U.S. Department
of Transportation
**Federal Highway
Administration**

In Reply Refer To:
HSSD/B-154

Thank you for your October 18, 2006, request for the Federal Highway Administration (FHWA) acceptance of the ESB bridge rail for use on the Tappan Zee Bridge. The proposed ESB rail is a steel tube railing you compared to the SISTEMA barrier originally accepted by the FHWA in our letter B-123 dated March 12, 2004. Accompanying your letter was a report titled "LRFD Rail Analysis–Nonlinear Static Incremental Analysis–Steel Side Barrier Types ESB and SISTEMA–Tappan Zee Bridge Repair Project" by Ammann & Whitney (A&W). You requested that we find this barrier acceptable for use under the provisions of the National Cooperative Highway Research Program (NCHRP) Report 350 "Recommended Procedures for the Safety Performance Evaluation of Highway Features."

BOLTING OPTION 50 FT BARRIER PANEL LENGTH

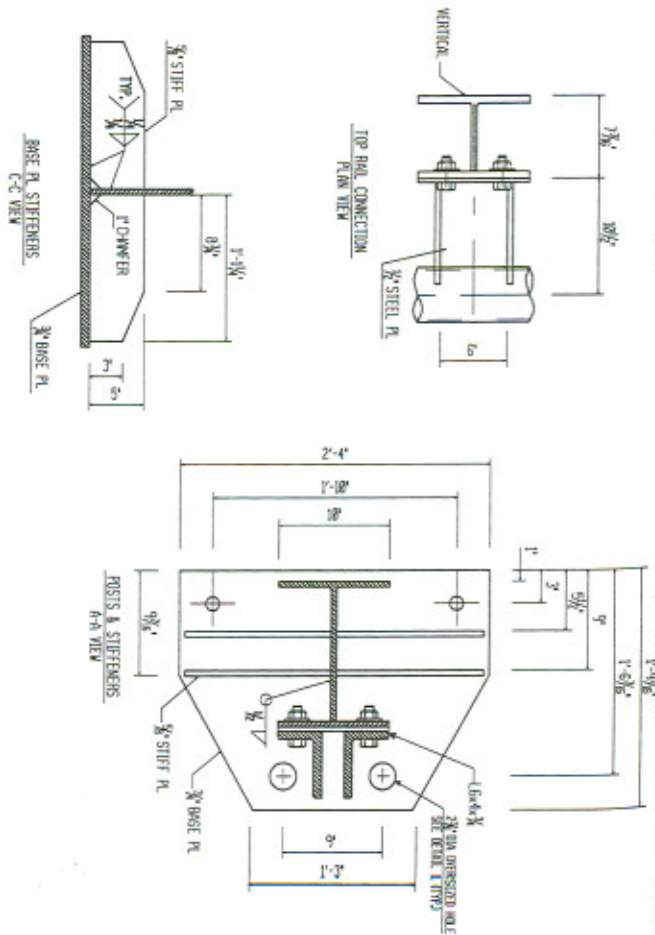
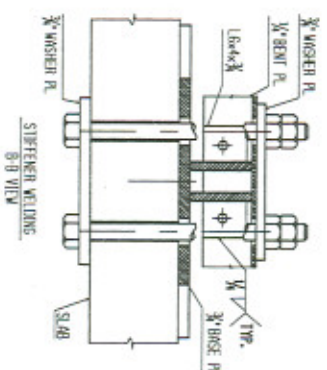
The A&W report concluded that the strength and overall barrier performance was satisfactory as compared to the ESB. The design specified an anchor bolt configuration in which some of the bolts were designed to break away prior to the application of the full design load. The FHWA Office of Infrastructure reviewed the A&W report and rejected the original ESB design because some of the bolts broke prior to the application of the minimum load of 120 kips, as required by the American Association of State Highway and Transportation Officials LRFD. The A&W redesigned the attachment bolts and stiffened the edge of the bridge deck in order to increase the loading that the rail system would tolerate before deflecting without damaging the bridge deck. The FHWA Office of Infrastructure concurred with the redesign.

The ESB bridge railing as redesigned, described above, is acceptable for use on the NHS as a test level 5 barrier.
